Safety Evaluation Report
for the American Centrifuge Plant
in Piketon, Ohio

Docket No. 70-7004

USEC Inc.

DRAFT

Figure 1-1 Simplified Base Curve Recommended for Calculation of CRR From the Standard Penetration Test Results (Modified from National Center for Earthquake Engineering Research, 1997)

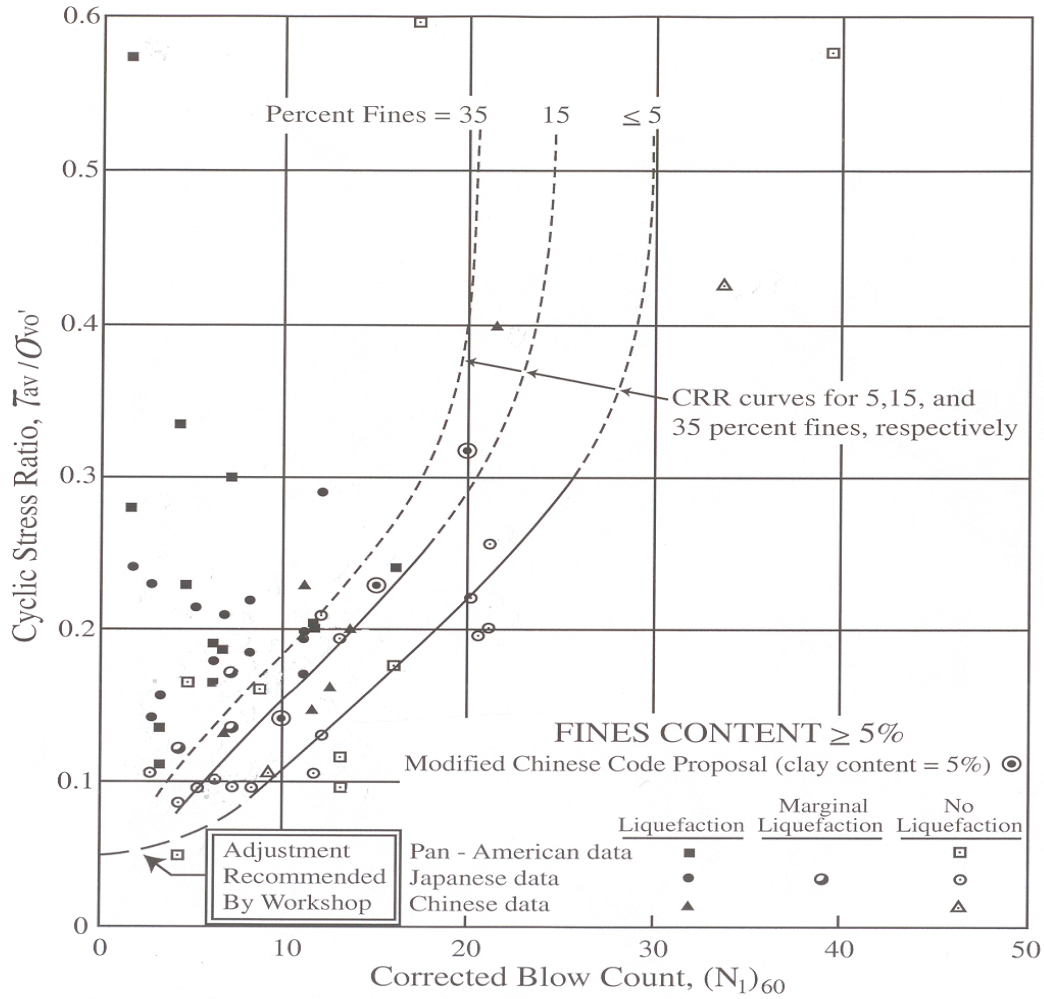
For earthquakes of different magnitudes, the CRR curves shown in Figure 1 must be scaled up or down on the diagram. The suggested magnitude scaling factors can be found in NCEER (NCEER, 1997). According to the LA (USEC, 2006c) and the ISA Summary (USEC, 2006b), the general design basis earthquake for the proposed ACP except the X-3346 building Customer Service Area has a Richter magnitude of 5.25 with a horizontal peak ground

acceleration of 0.15g. The magnitude scaling factor for this earthquake magnitude is at least 1.43. The magnitude scaling factor of 1.43 is suggested for an earthquake of magnitude 5.5 and may be considered as a bounding value compared with the values suggested by other researchers (Table 3, NCEER, 1997). Applying this scaling factor, the CRR curves in Figure 1-1 represent a safety factor of at least 1.43 for earthquakes of magnitude 5.25.

Figure 3-1a ISA for the ACP

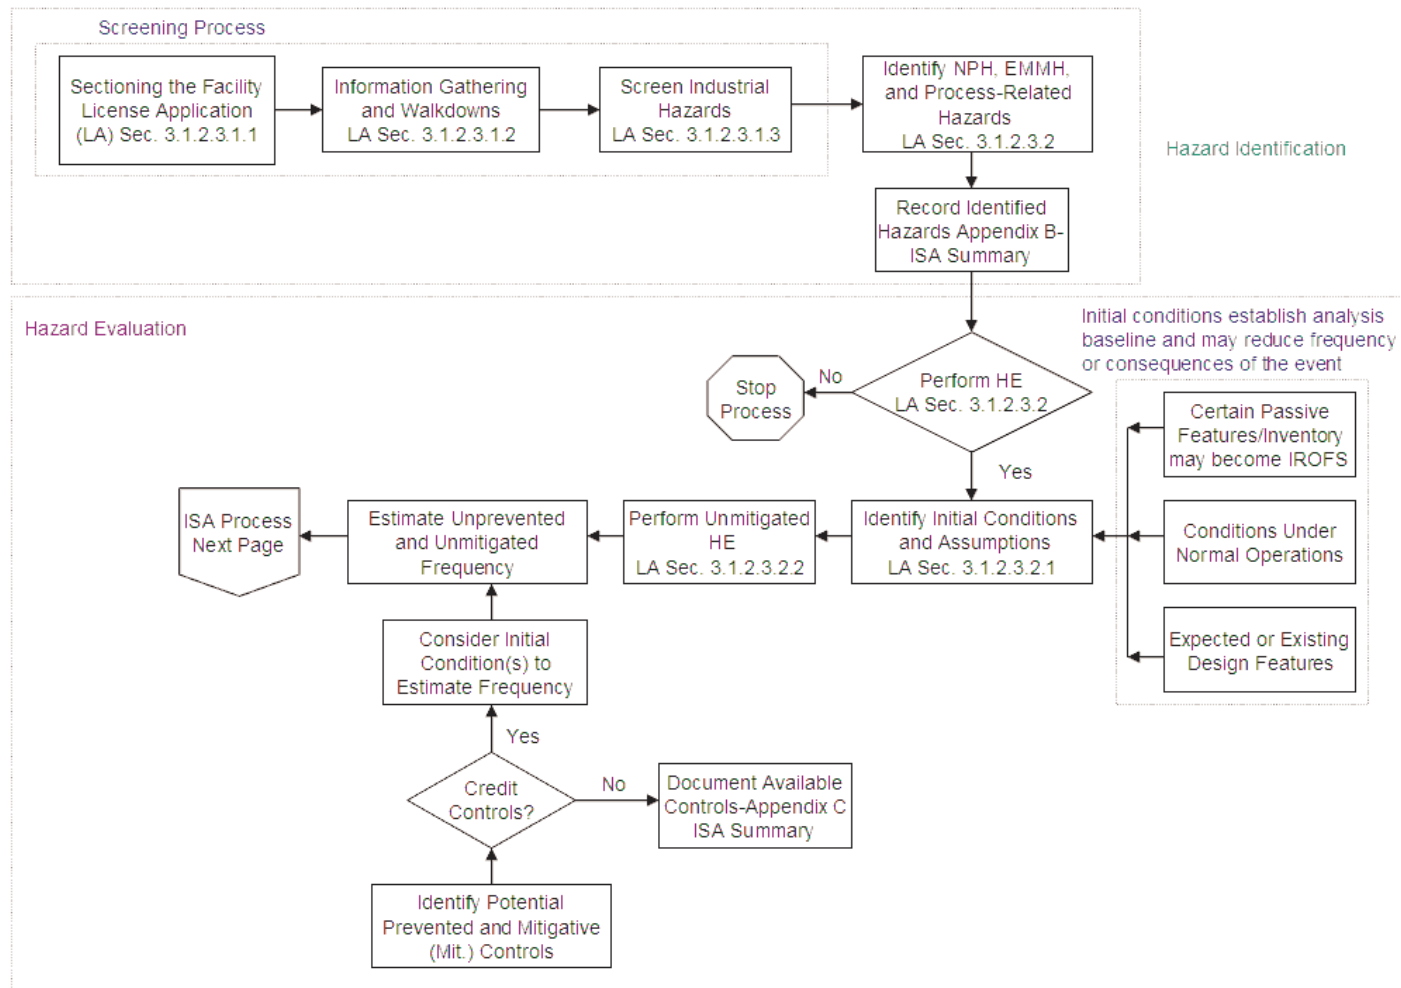
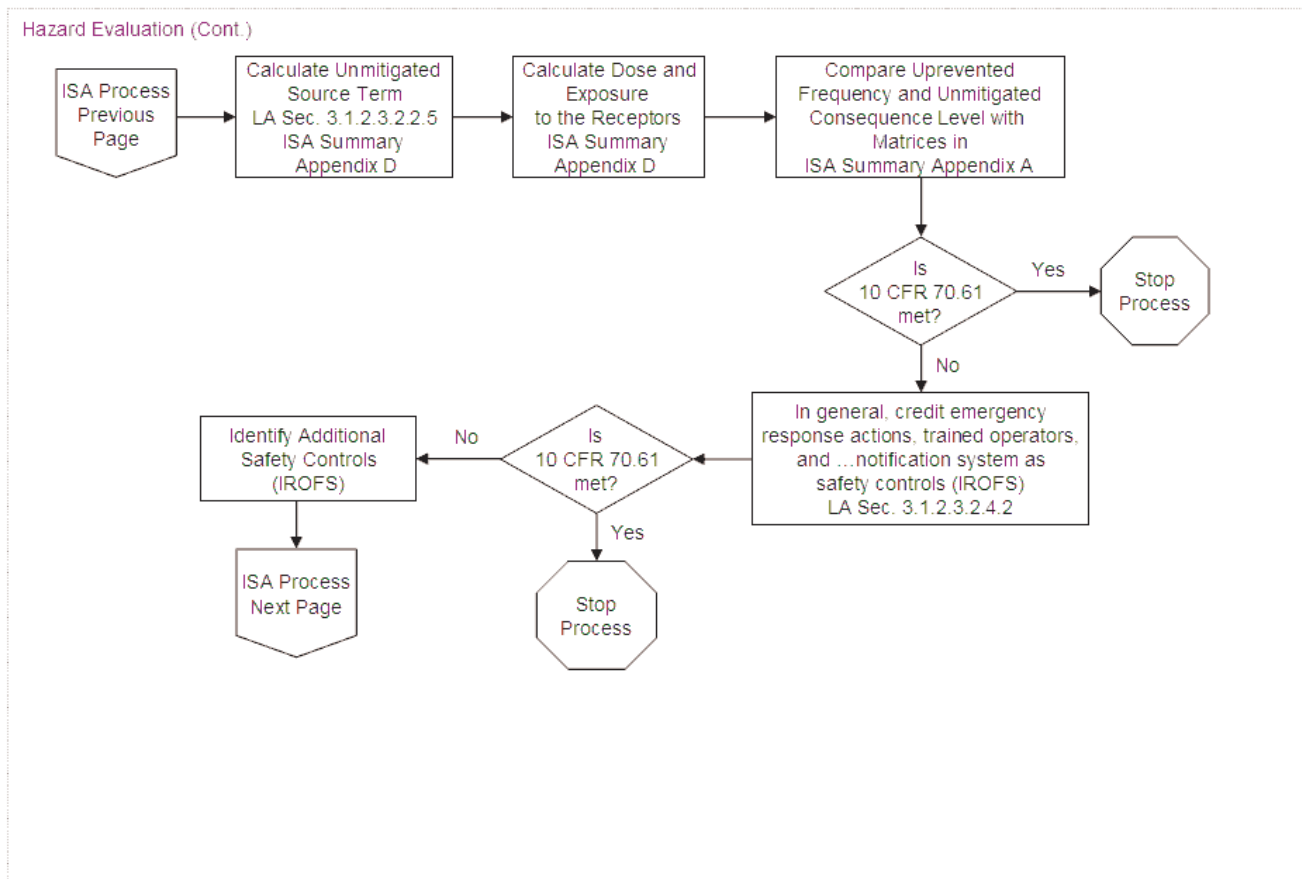
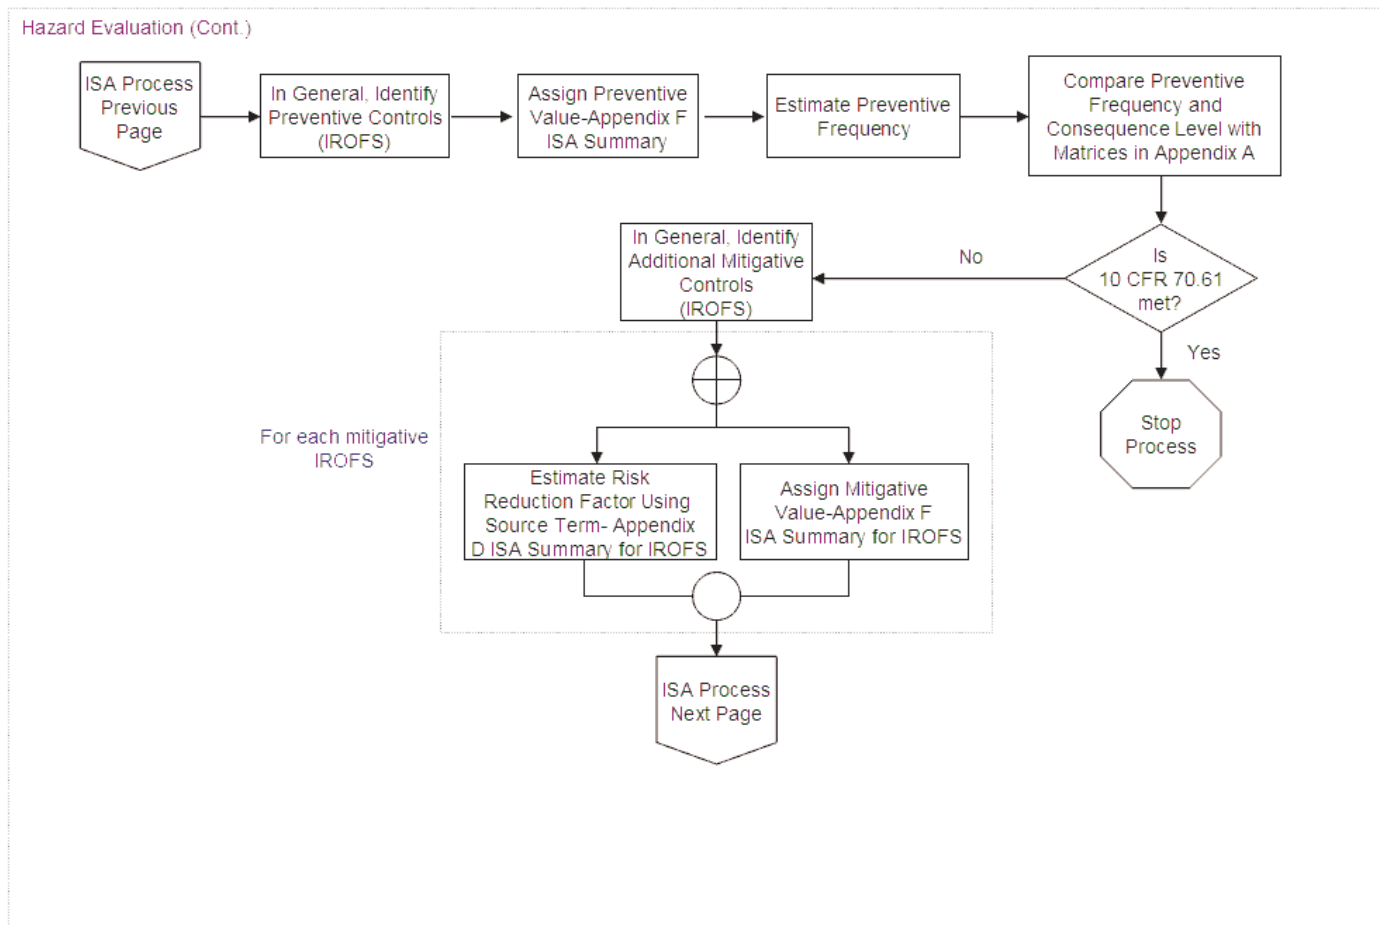
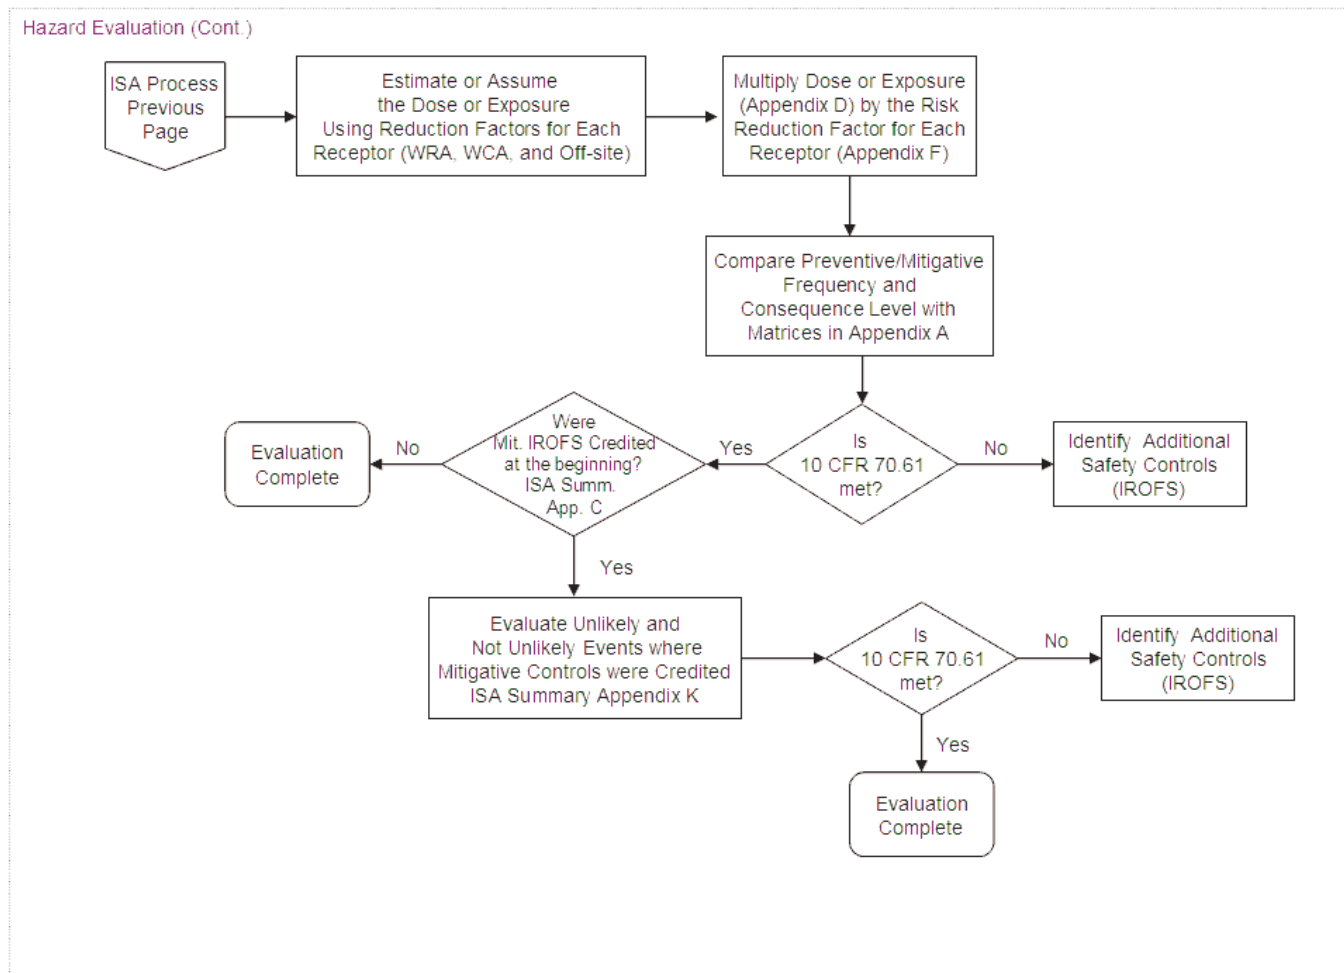
The following sections describe the applicant's ISA methodology. This methodology is also described graphically as a flow diagram in the following Figures 3-1a through 3-1d.

The hazard analysis for the ISA is developed using two primary activities: (i) hazard identification and (ii) hazard evaluation. These activities result in the estimates of consequences and frequencies such that scenarios can be identified that have a potential risk to the public, workers, and the environment that exceeds the 10 CFR 70.61 performance requirements. The hazard identification process is shown in the top boxed-in set of ISA process steps in Figure 3-1a. The hazard evaluation process is comprised of the rest of the process steps shown in Figures 3-1a - 3-1d.

If the 10 CFR 70.61 performance criteria are not satisfied, the process progresses as shown at the start of the process as shown in Figure 3-1c where available preventive controls are credited to meet the performance requirements. These controls are selected in an order of preference. If available, engineered or designed controls will be selected before administrative controls, to utilize the inherent reliability advantage of designed systems or components over that of required human action compliance. Defense-in-depth concepts utilizing non-credited controls were also incorporated into the control strategy for a postulated event whenever possible according to Section 3.1.2.3.2.4 of the LA (USEC, 2006b). These defense-in-depth controls are generally controls that were listed as available when the sequences were formulated but not explicitly required to meet the performance requirements.

The final steps in the ISA analysis are shown in Figure 3-1d. This step of the analysis evaluates the likelihood of failure of mitigative IROFS for events that are not prevented or made to be "highly unlikely." Events for which mitigative controls were credited were evaluated to examine the residual risk associated with the postulated failure upon demand of each mitigative IROFS. The approach used in the evaluation developed a series of sub-events designed to demonstrate that the risk of the event following failure of one or more mitigative controls is still within the 10 CFR 70.61 performance requirements. This evaluation is described and tabulated in Appendix K of the ISA Summary (USEC, 2006a).
